Technical Service Bulletin: TSB220008

New Exhaust Muffler Bracket

- QSK60 CM2150 MCRS

Figure 2, New Part Number 5542739.

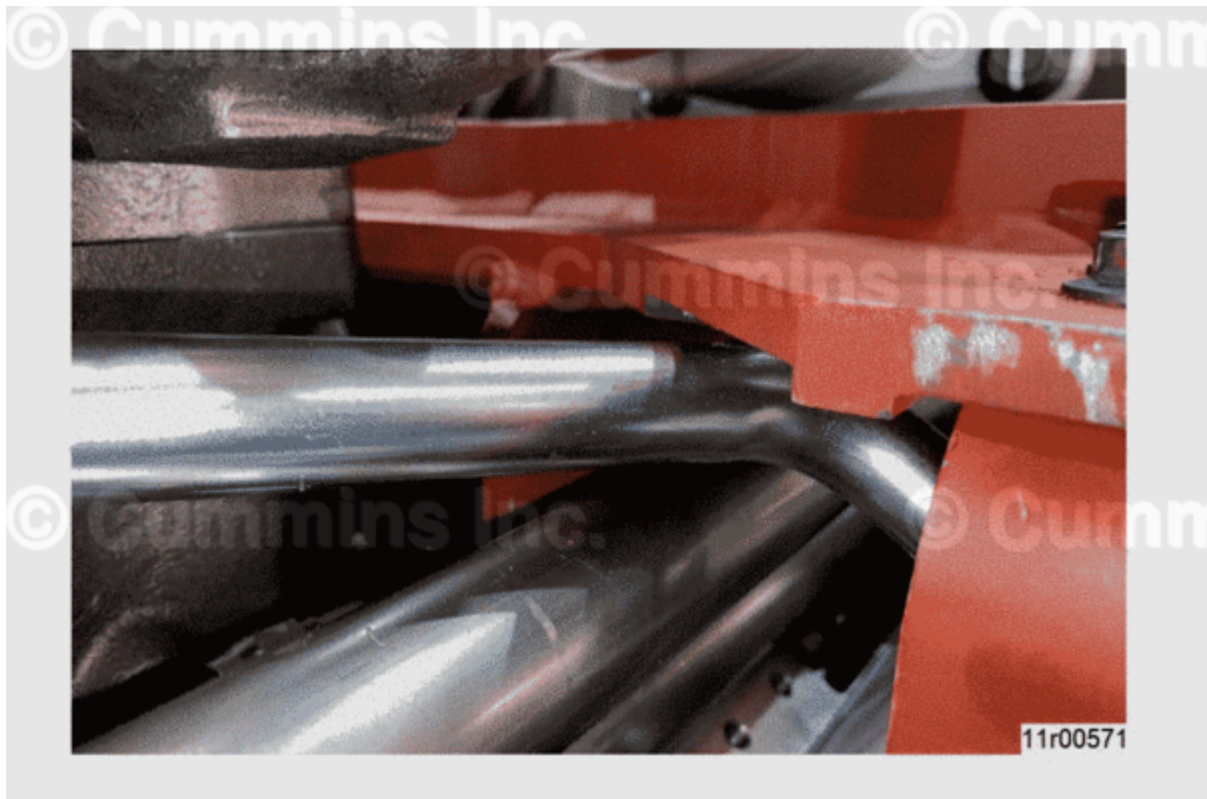
A new exhaust muffler bracket with a cutout for increased clearance for turbocharger oil drain line is now available.

There is interference between the turbocharger support bracket and the turbocharger oil drain line. This contact can lead to fretting damage to the turbocharger oil drain line tubing.

New part can be identified by part number stamping on the component and by the cutout as shown in Figure 2 below.

- Order existing or new part number to resolve clearance issues. All existing part number stock has been re-worked to match new part number and can still be used.
- If installing the new exhaust muffler bracket and a thicker spacer has been added to the turbocharger oil drain line at the turbocharger connecting joint, this can be removed and restored to the original factory design using correct cap screws and new gaskets.
